CALIFORNIA COASTAL COMMISSION

REVISED FINDINGS

Consistency Determination No.: **CD-0001-21**

Project Description: A 7.5-mile multi-use bicycle and pedestrian trail that would extend along the RTC-owned railroad corridor

Figure 4: Trail re-alignment alternatives. The proposed trail is in red. Photo: FHWA.

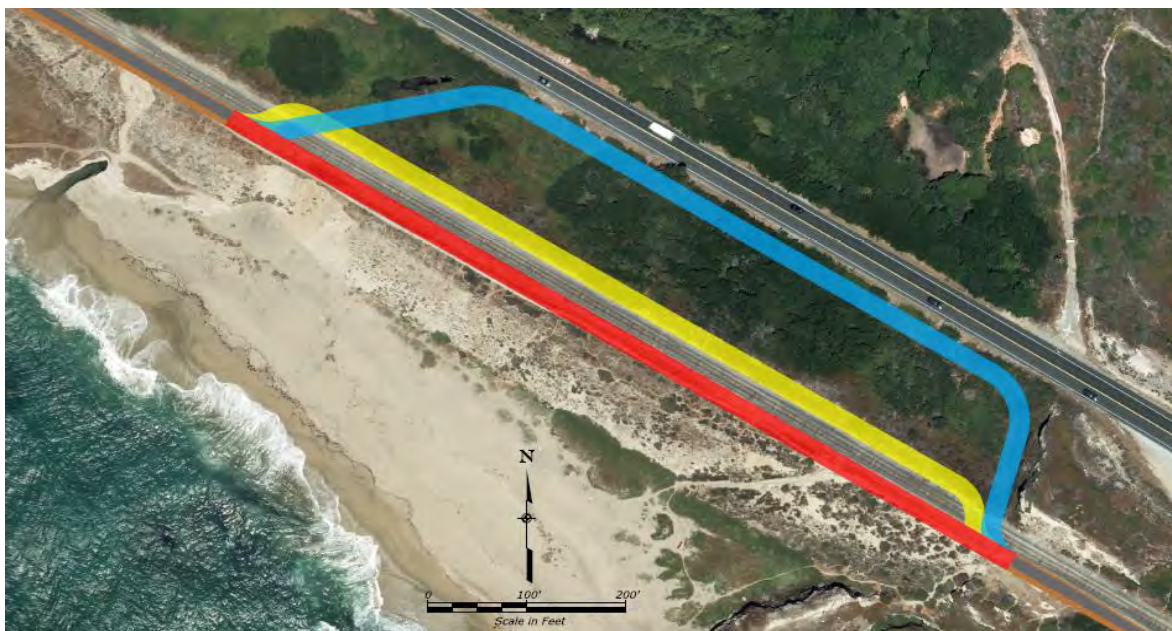
FHWA has also stated that both realignment alternatives would require two new rail crossings, which could create a safety hazard if the rail becomes operational in the future. Introducing two new railroad crossings near the slope failure could potentially conflict with future rail services due to safety requirements for rail crossings, which are subject to approval of the California Public Utilities Commission. Alternatively, the nearest approved crossings to the north and south are located .25 miles (north) and 1.0 mile (south) from the slope failure location. To provide an inland trail alignment for 1.25 miles between these crossings also requires private property acquisition, and demolition of an existing building, which would increase environmental impacts to coastal shrub, and reduce coastal views and ocean vistas by locating the trail farther from the coast and below the grade of surrounding coastal bluffs.

added railroad crossings. In addition, it would move the public further from the coast and create steep grade changes that are undesirable for the public. Currently, although it is difficult to see in **Figure 4**, the topography of the land between the highway and the trail is an uneven elevation, so there is not a clear view of the coast from the highway, denying the public the aesthetic benefits afforded by the trail. Additionally, under the current administrative structure of the project and funding, FHWA and RTC can only develop along the immediately adjoining shoulders of the rail, and thus moving the trail inland and separating it from the rail is not presently feasible. FHWA and RTC did not pursue a realignment option that would extend the trail directly from the proposed Davenport parking lot, along Highway 1, and that may cross over land with one rail crossing south of the failing embankment.

Regarding the potential need for additional rail crossings, the Commission acknowledges agreed that there may be logistical and permitting challenges associated with introducing the new rail crossings that would allow for an inland realignment of the trail. As described by public officials at the project hearing, the County would likely have to close two existing rail crossings in order to create two new ones here; however, there is evidence that the County does not have two crossings that it could close, thus putting into question the feasibility of this alternative. From a safety perspective, ~~However,~~ there is currently little evidence to suggest that the construction of safe crossings, meeting the standards of the CPUC, is infeasible in the project area. Furthermore, as described above, the future of the rail along this stretch of the coast is uncertain. Although there are proposals to reactivate the rail for use as a recreational railway, these proposals are aspirational-still under consideration at this point in time. It is also possible that the rail will be decommissioned in the future, thus eliminating the need for official crossings and opening up additional alternatives for the trail.
